September 8, 1998

RE: REVISED DRAINAGE PLAN FOR BOB'S BURGER @ EUBANK (K20-D49)  
REVISION DATED 8/20/98

RE: ENGINEER CERTIFICATION FOR BOB'S BURGERS @ EUBANK (K20-D49)  
CERTIFICATION STATEMENT DATED 10/3/98

A PROPOSED GRADING-DRAINAGE PLAN

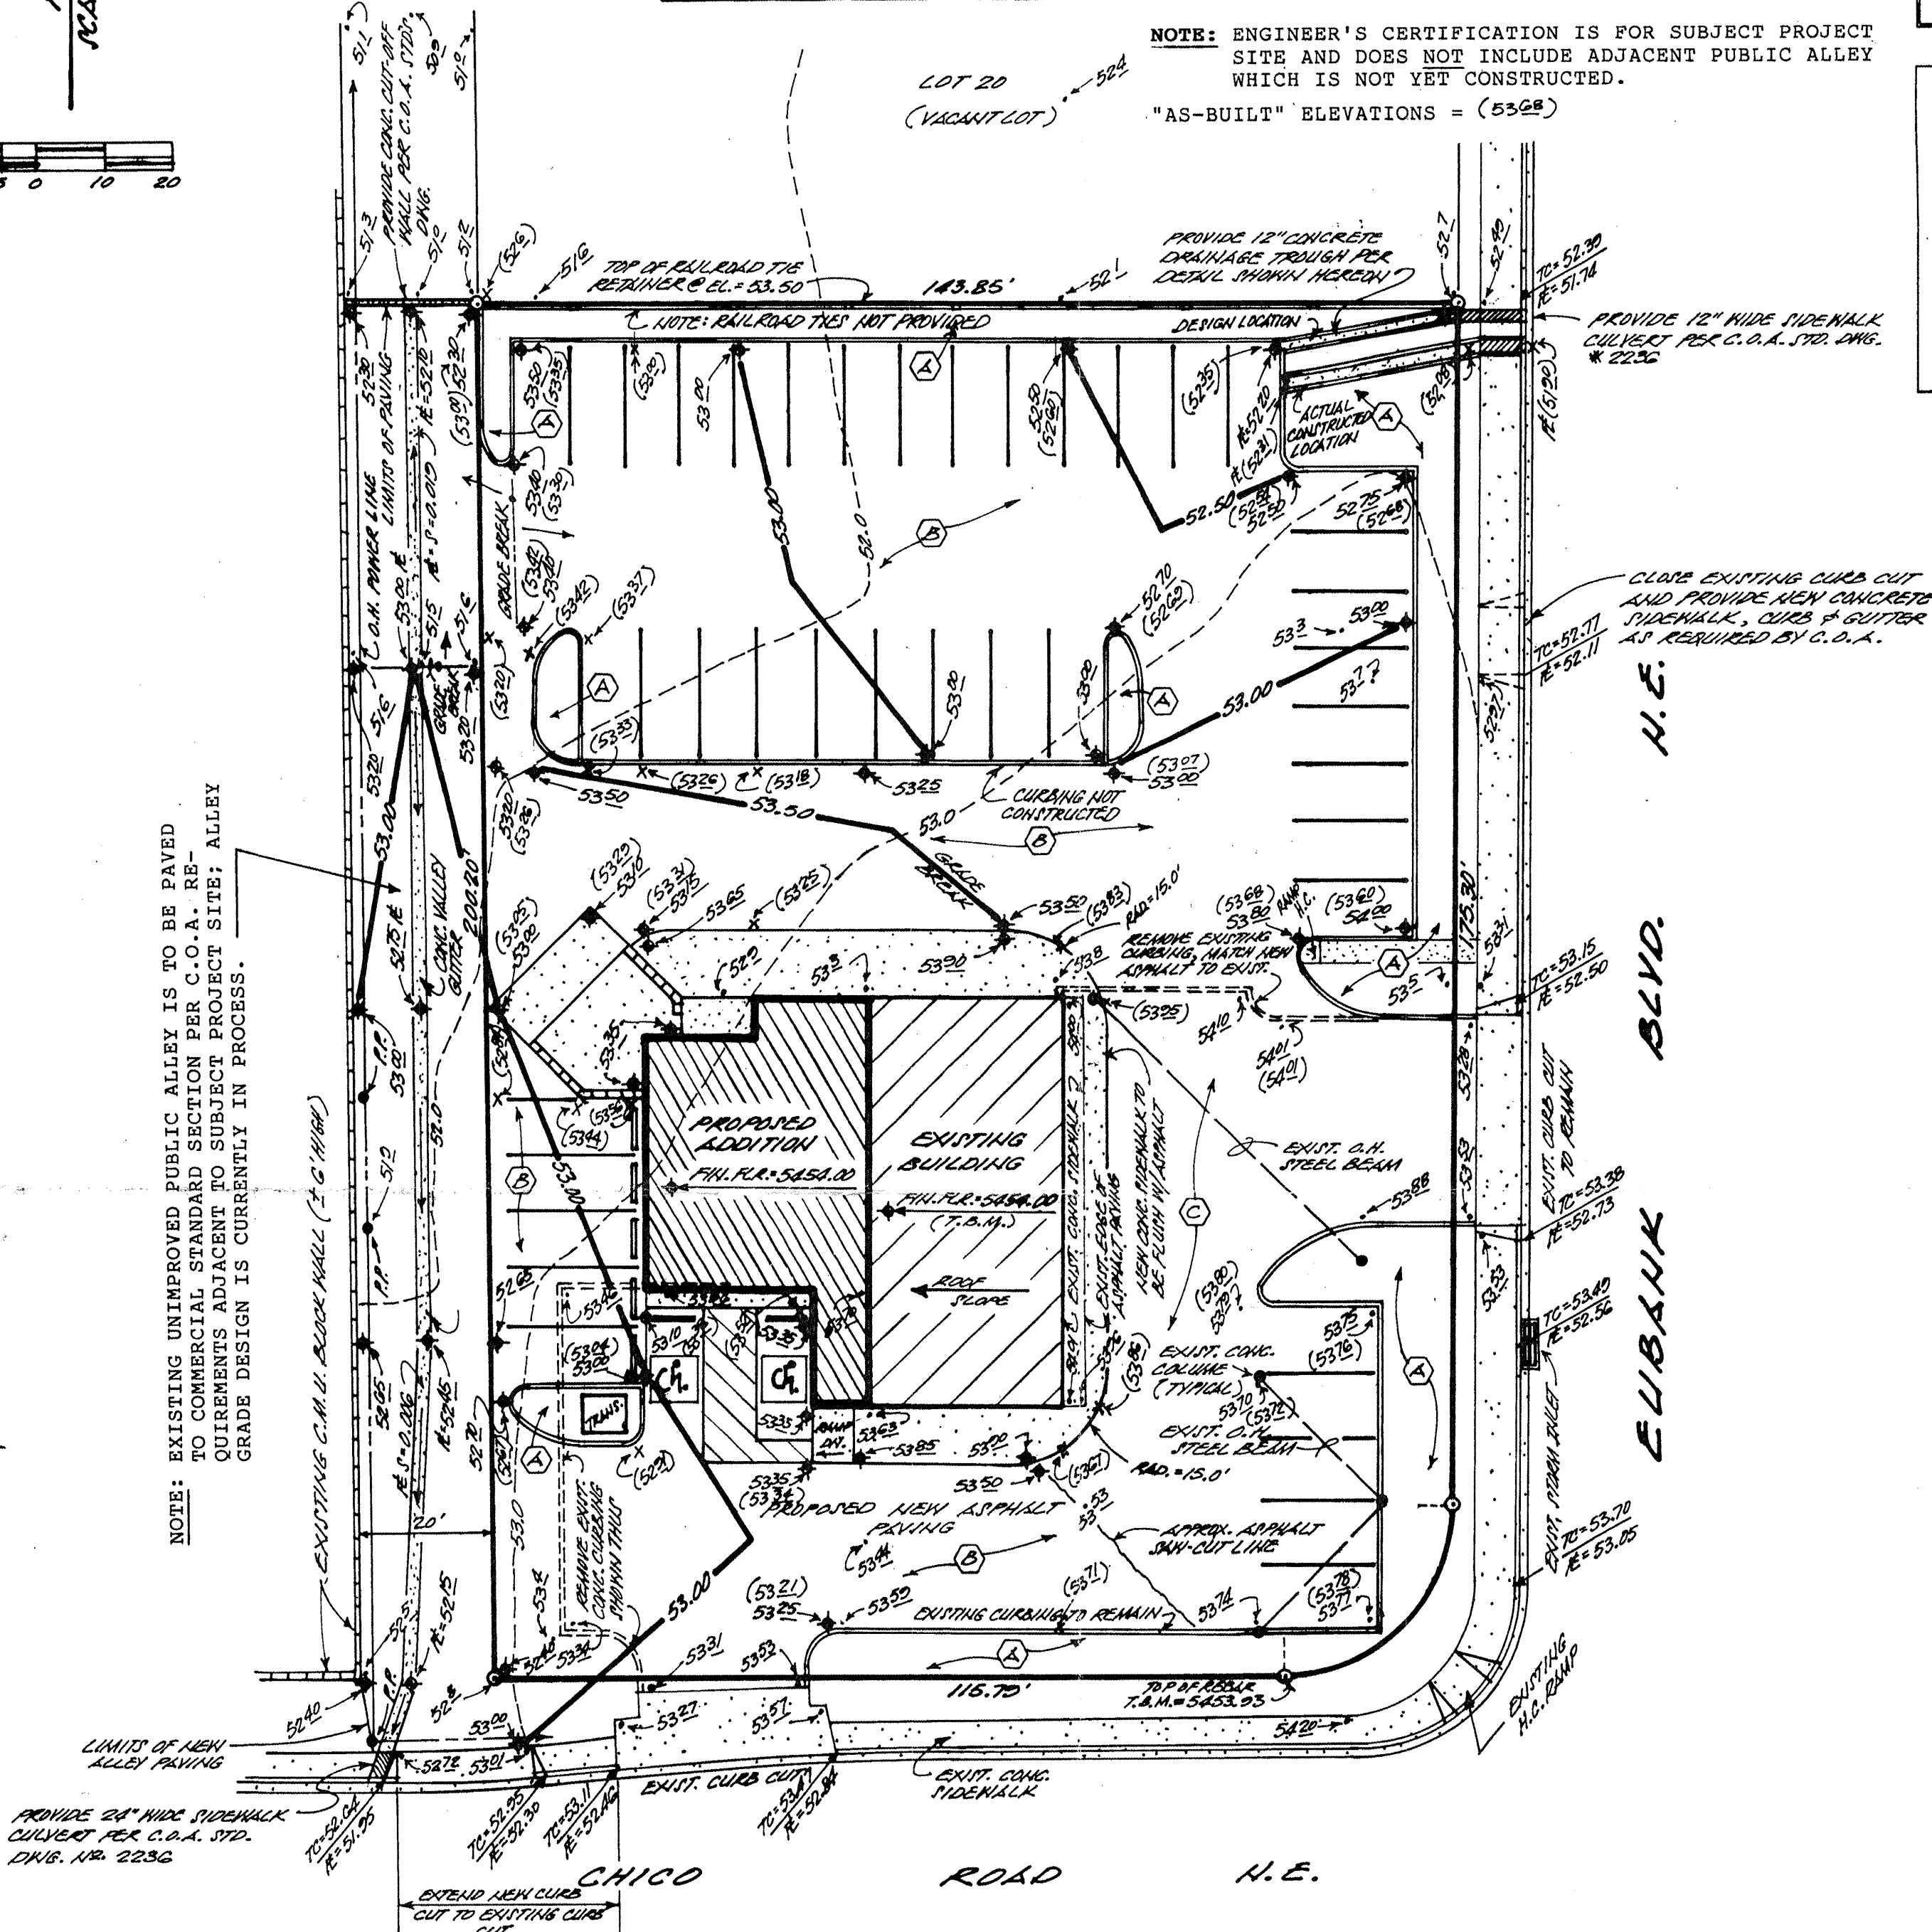
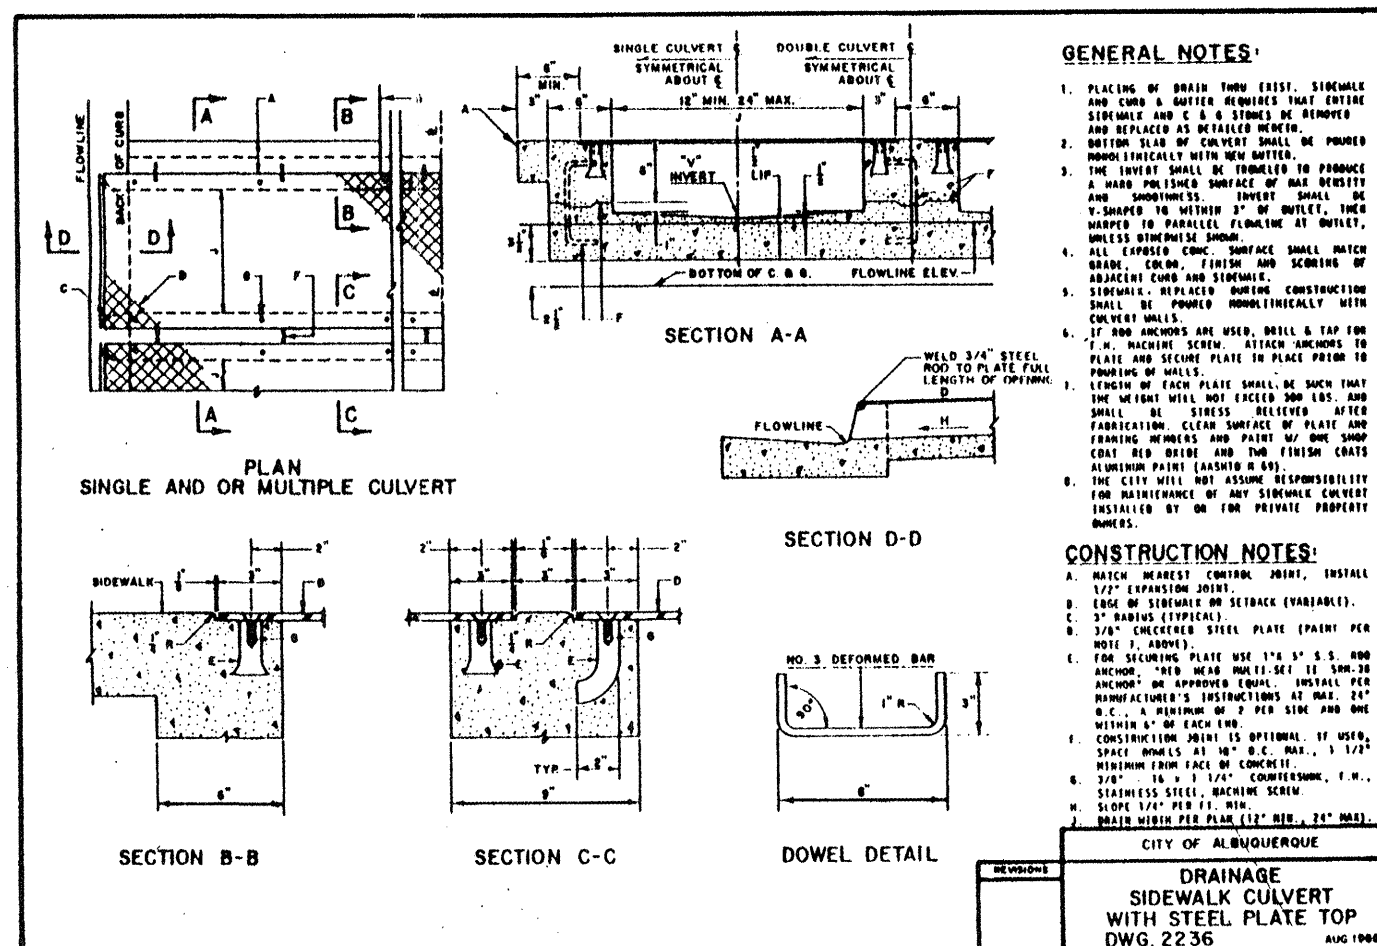
Based on the information provided on your October 5, 1998 submittal, Engineer Certification for the above referenced site is acceptable.

Please be advised that the final Certificate of Occupancy will not be released until the alley design and alley improvements are completed and certified.

A PROPOSED GRADING-DRAINAGE PLAN  
FOR  
BOB'S BURGER  
(305 EUBANK BLVD. N.E.)  
ALBUQUERQUE, NEW MEXICO  
AUGUST, 1998

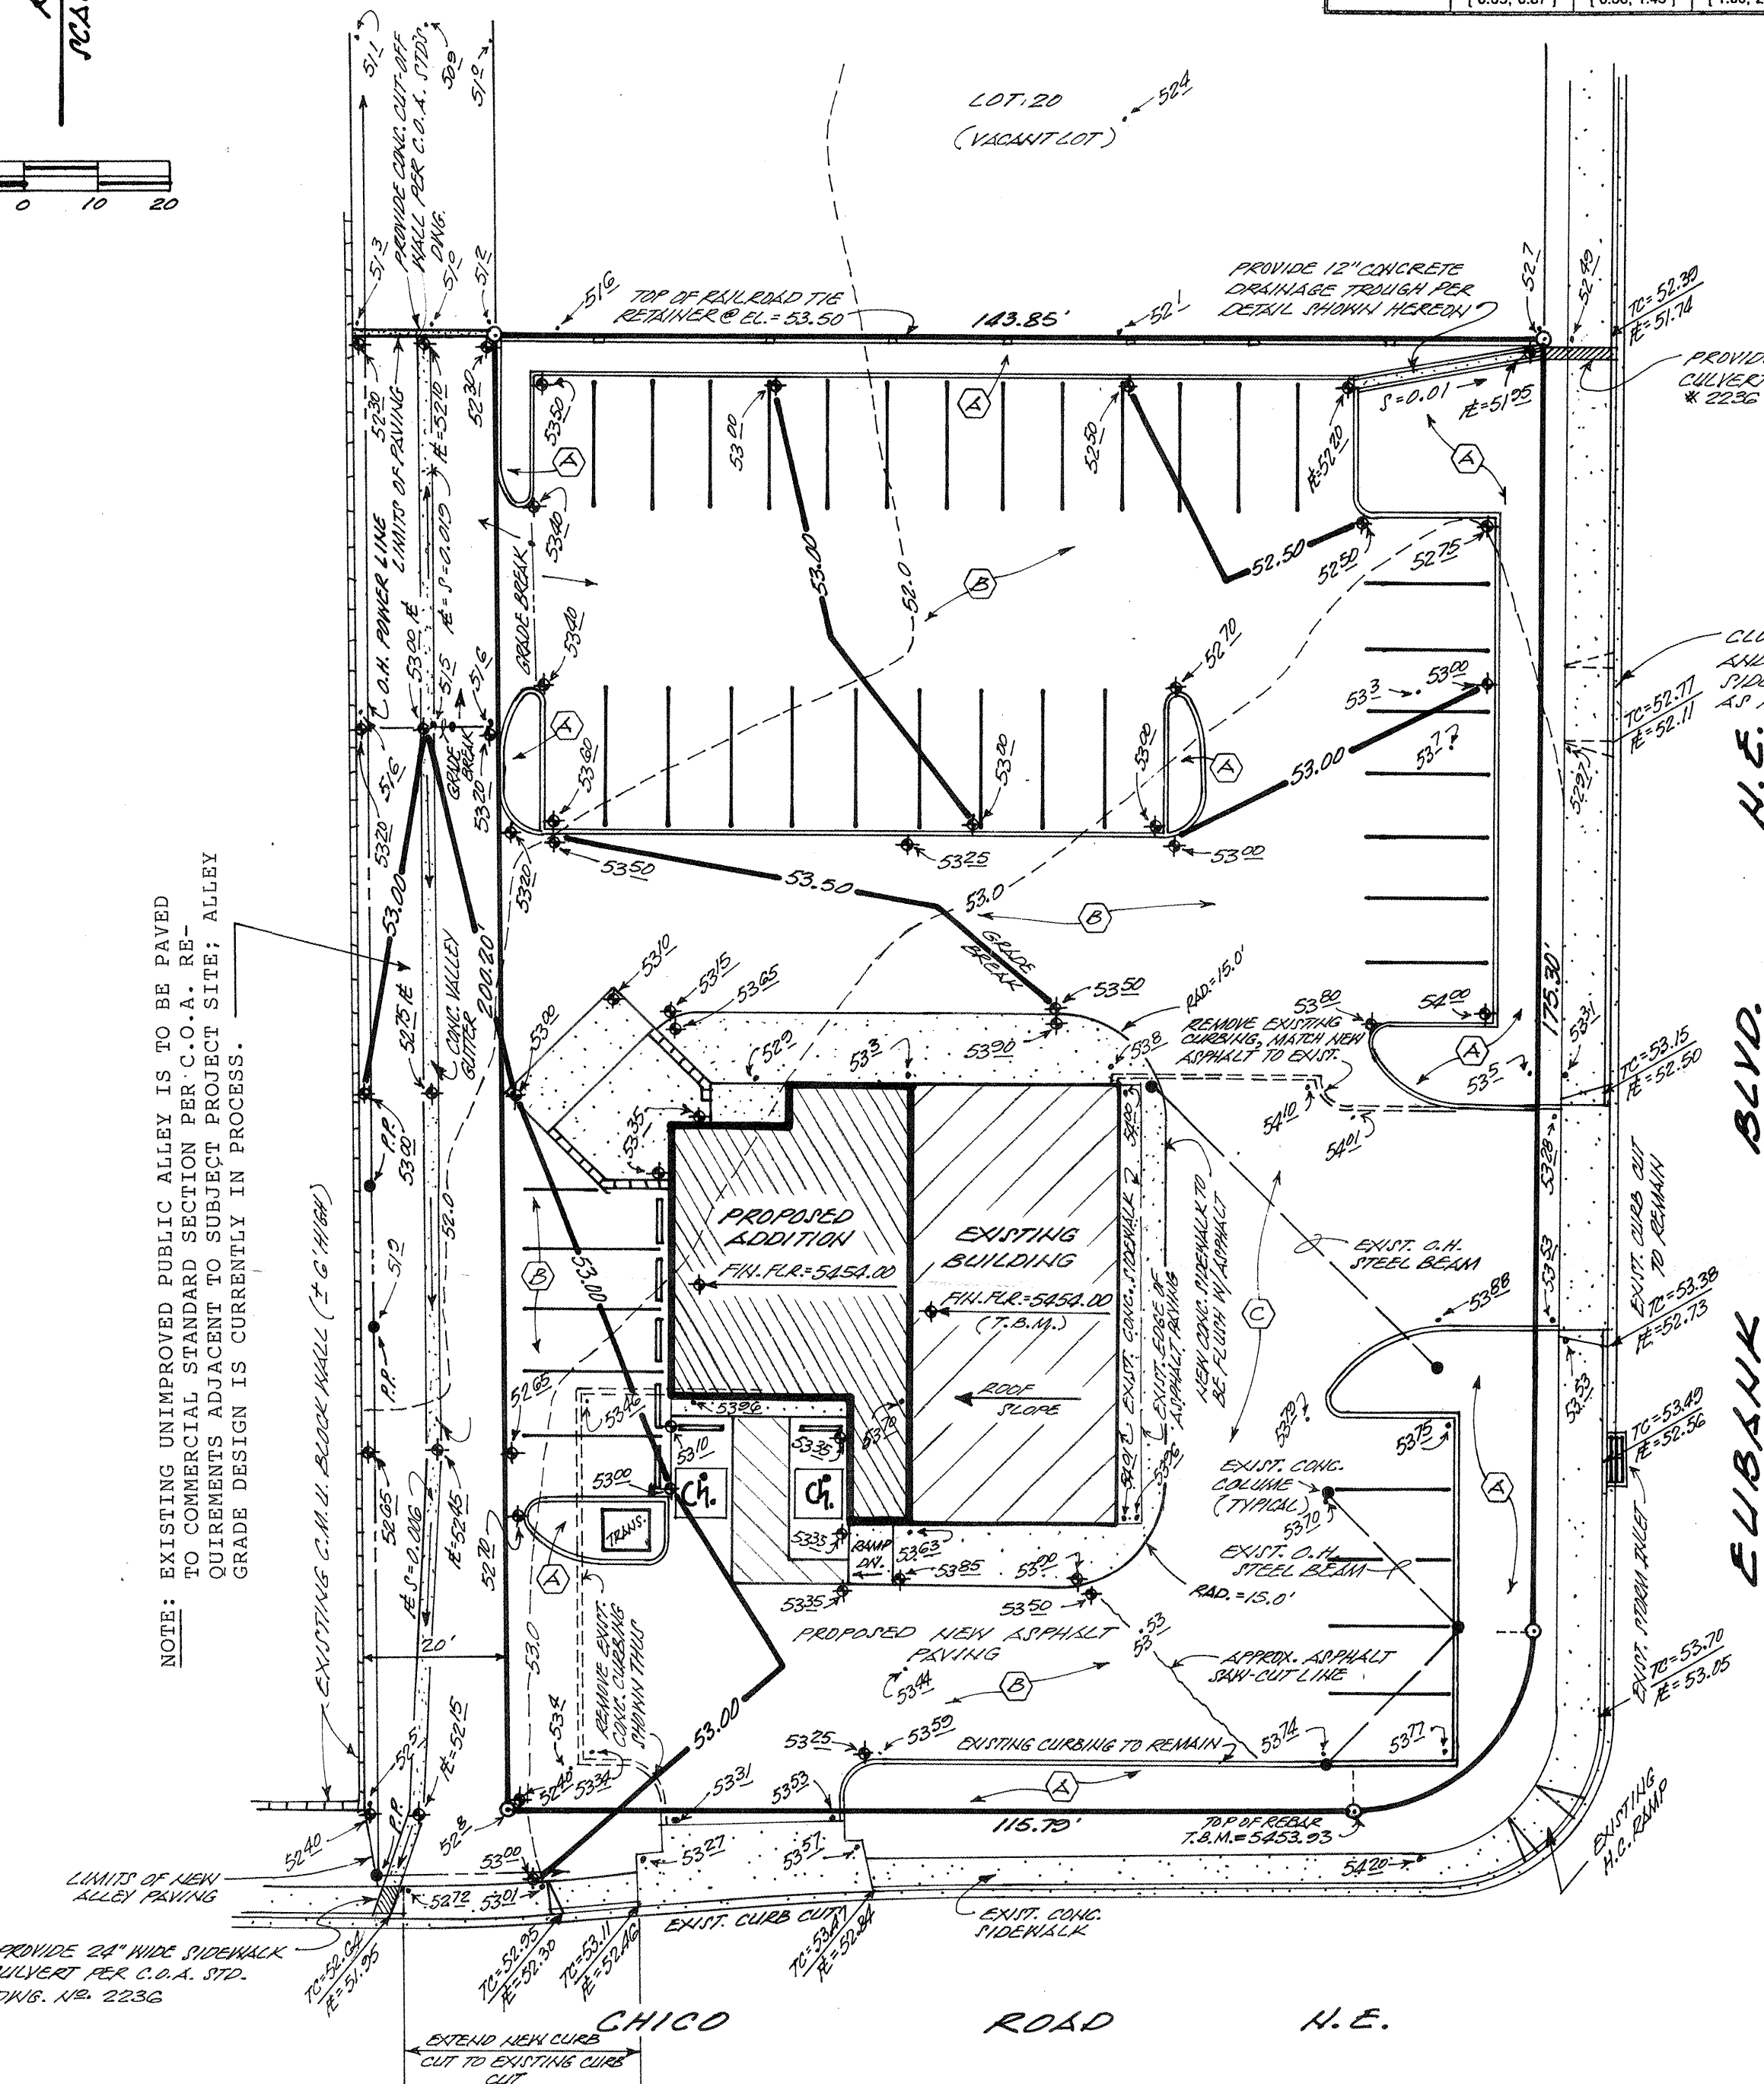
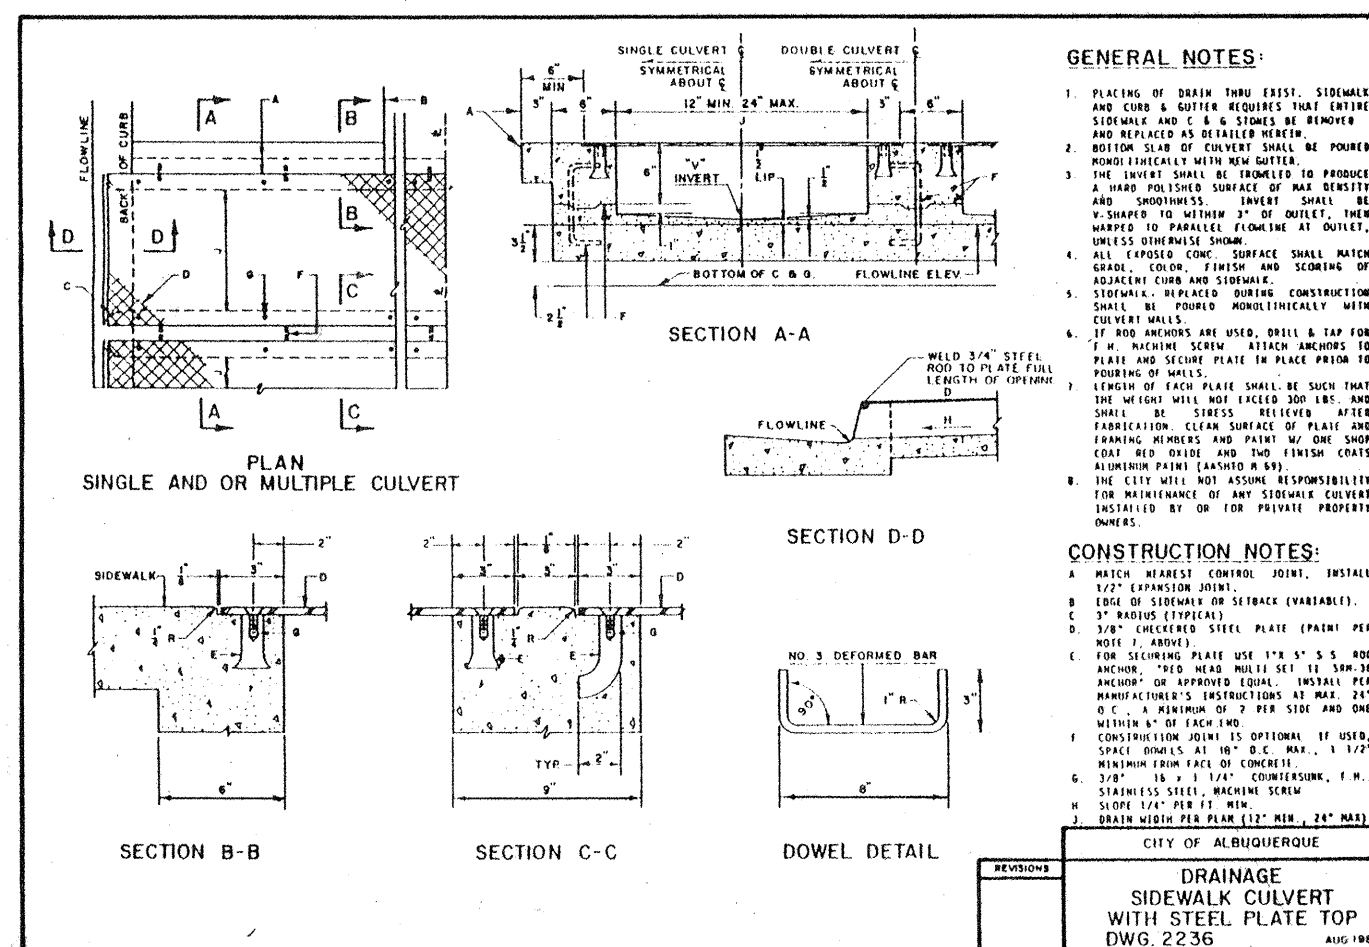
Based on the information provided on your August 24, 1998 resubmittal, the above referenced site is approved for Building Permit.

Please attach a copy of this approved plan to the construction sets prior to sign-off by Hydrology.

Also, prior to Certificate of Occupancy release, Engineer Certification per the DPM checklist will be required and also Work Order acceptance for the alley improvements.

The proposed sidewalk culvert within the alley section will be part of the W.O., therefore eliminating the SO 19 process.
